Subject: 06160 – Product Safety Recall

Fuel Tank Adhesive Layer Missing

Models: 2007 Buick Allure, LaCrosse

Bulletin No.: 06160

1865554

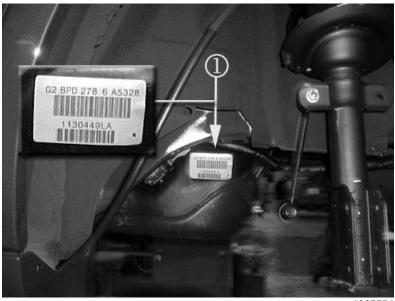
2. Locate the fuel tank serial number (1), which is on the driver's side of the tank and usually visible through the rear driver's side wheel well.

- 3. Compare the fuel tank's serial number (1) to the tank serial numbers below.
 - o If the serial number on the fuel tank **is not** listed below, no further action is required.
 - If the serial number on the fuel tank is listed below, the fuel tank requires replacement. Refer to Fuel Tank Replacement in SI. Do not discard the fuel tank. Refer to the section titled, Fuel Tank Cleaning and Packaging Information found in this bulletin.
